Findings of Fact | Site Plan Review

City of Portsmouth Planning Board

Property Address: 212, 214, & 216 Woodbury Avenue

Application #: LU-22-129

BIORETENTION SYSTEM BERM WITH CLAY CORE

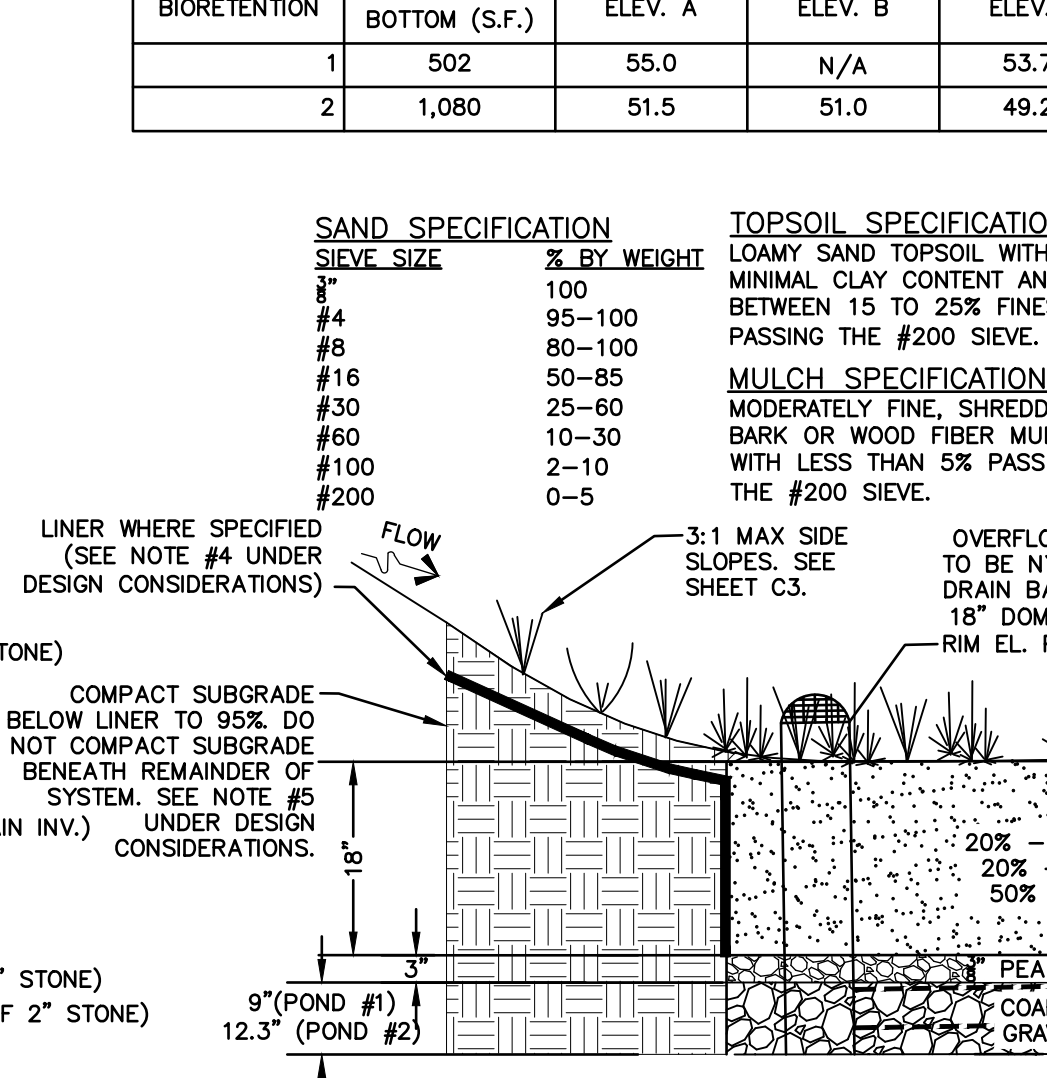
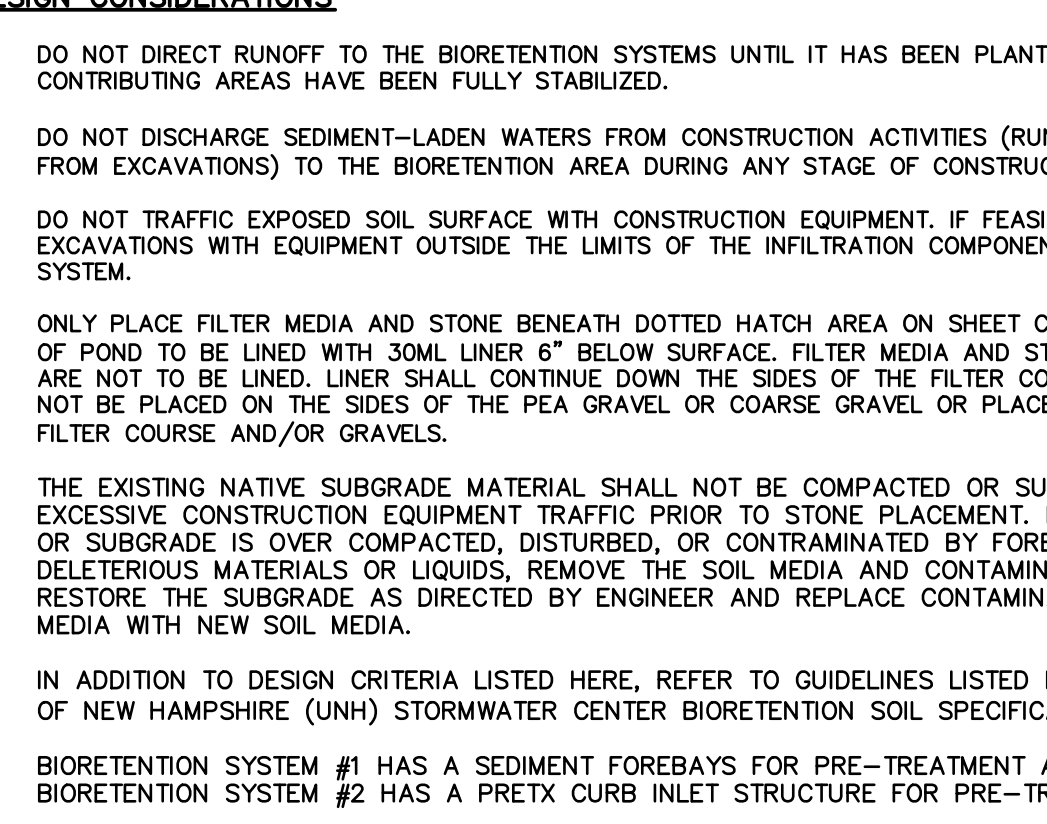
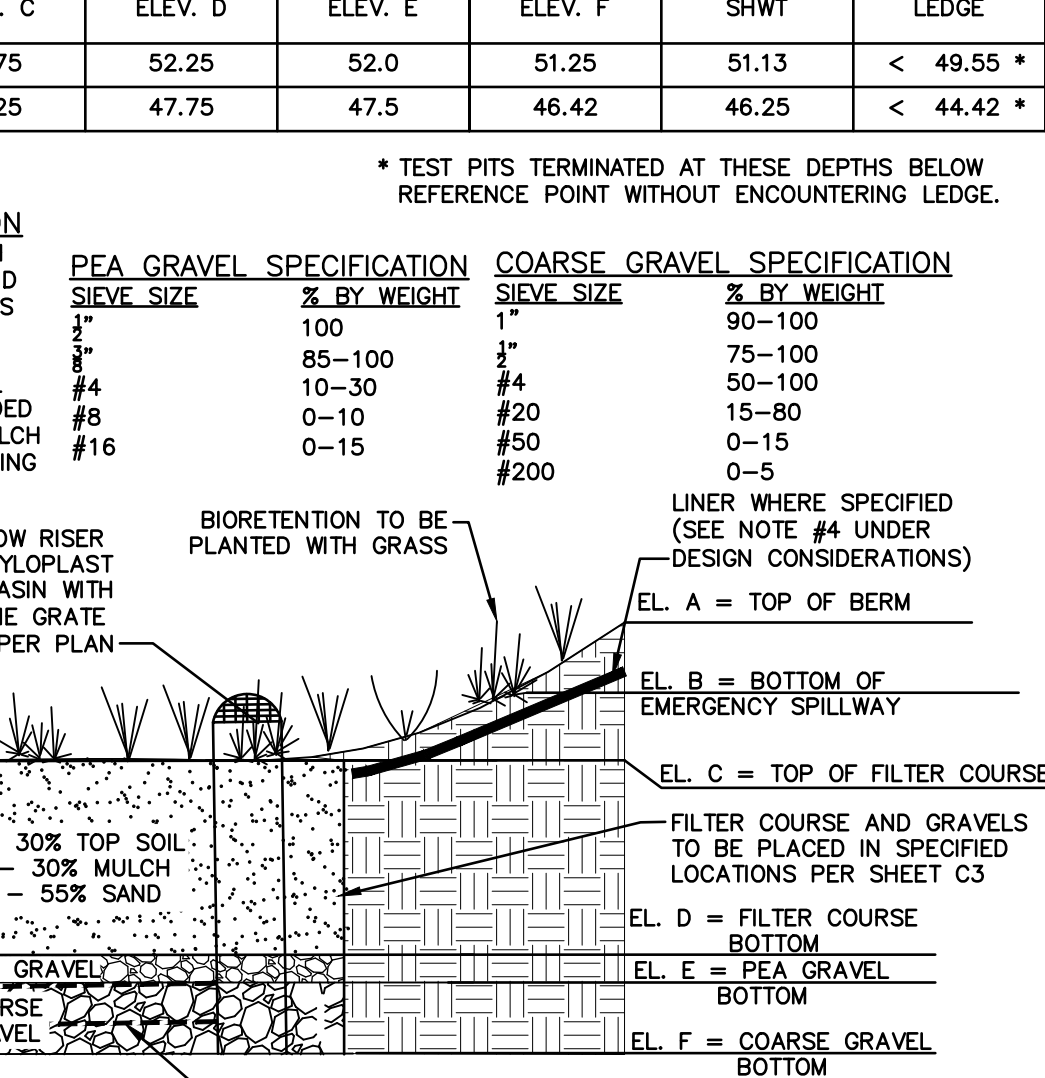
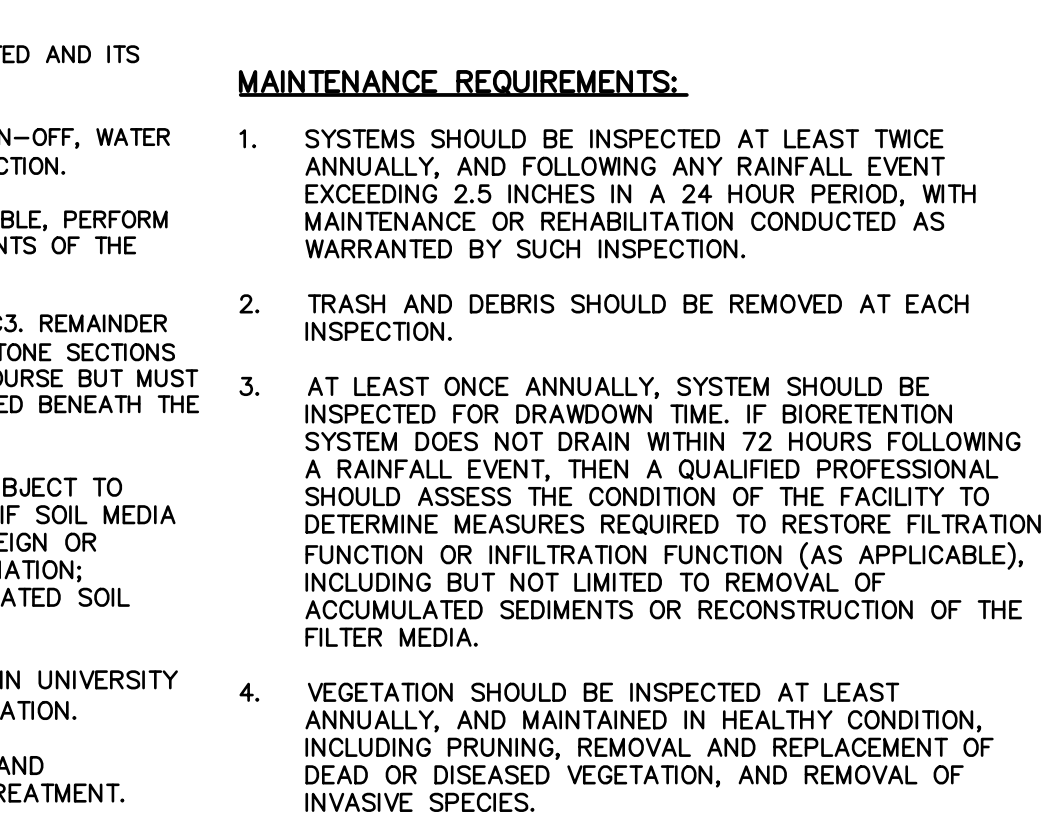
Altus had some minor concerns with the clay core detail depicted on the January 19, 2023 submission set. We discussed this with JBE. They revised the detail and resubmitted sheets D4 and D5 on January 31, 2023. The new submission addressed the concern.

9	1/23/23	REVISED BIORETENTION BERM DETAIL PER REVIEW ENGINEER	DJM
8	1/19/23	REVISED PER REVIEW ENGINEER AND CITY COMMENTS	DJM
7	12/20/22	REVISED PER REVIEW ENGINEER AND CITY COMMENTS	DJM
6	10/18/22	REVISED PER REVIEW ENGINEER AND TAC COMMENTS	DJM
5	9/23/22	REVISED PER UTILITY COMPANY	DJM
REV.	DATE	REVISION	BY
